## ATTACHMENT 3, SAFETY EVALUATION FORM

ISFSI - Transfer Cask Lead Silver Content Non Conformance

72.48 Log No.: SE00054

ES199601368

Figure 1  
Basket Geometry – NUHOMS 32P DSC

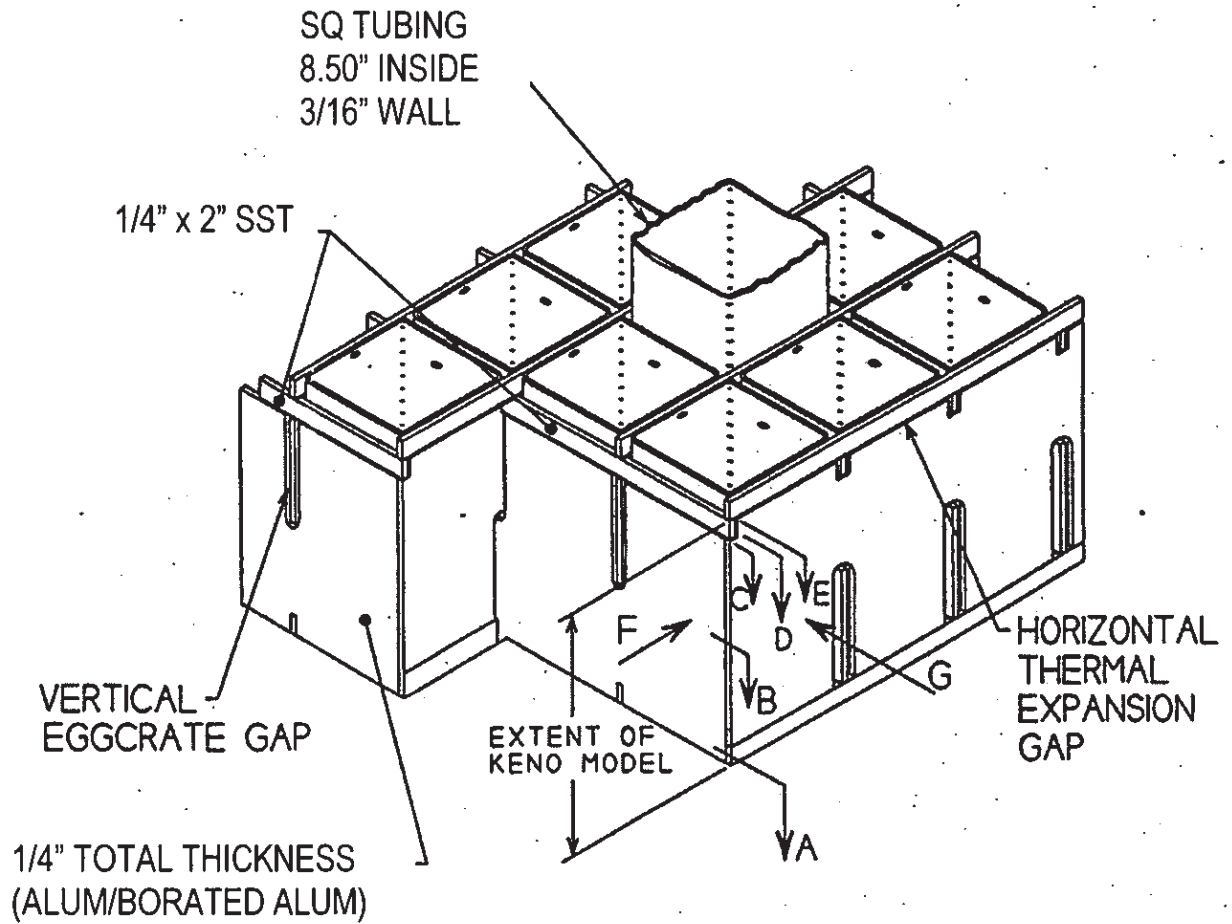
Major components of the NUHOMS-32P DSC consist of guide sleeves, egg-crate plates (borated and un-borated), peripheral steel rails with aluminum inserts, end shield plugs, DSC shell, and end cover plate (see figures 1 and 2). Location of the vent and siphon ports have been moved from the DSC shell wall (in NUHOMS-24P DSC) to the DSC shield plug (in NUHOMS-32P DSC). This change is made to improve the welding operation of the shield plug to the DSC shell. Similar to the NUHOMS-24P DSC, the NUHOMS-32P DSC serves to provide confinement, shielding, criticality control, and structural integrity of the fuel during transit and storage of the spent fuel assemblies.

Numerical Values of the differences are tabulated in Table 1.

Parameter	NUHOMS-24P DSC	NUHOMS-32P DSC
No. of Fuel Assemblies	24	32
Guide Sleeve Dimension	8.7"x 8.7"	8.5"x 8.5"
Guide Sleeve Spacing	10.36"	9.125"
Lead Shielding Thickness - Top Shield Plug	4.375"	4.00"
Top Shield Plug Top Casing Plate	0.375"	0.75"
Spent Fuel Pool Min. Boron 10 Concentration	1800 ppm	2450 ppm
Borated Aluminum Plates – Boron Content	None	0.01 g/cm <sup>2</sup>
Fuel Assembly Mass	0.386 MTU (Nominal)	0.400 MTU (Maximum)
Neutron Source	2.23E+08 n/s/assy	3.3E+08 n/s/assy
Fuel Assembly Weight	1300 lbs <sup>(1)</sup>	1450 lbs
Loaded Dry DSC Weight	65.0 kips	91.0 kips
Total Heat Source (0.66 kW/assy)	15.84 kW	21.12 kW
DSC Shell Design Pressure (Accident Condition)	50 psig	100 psig
Blocked Vent Restoration Time	24 hours	12 hours
Optimum Moderation Assumption	Pure Water	Borated Water
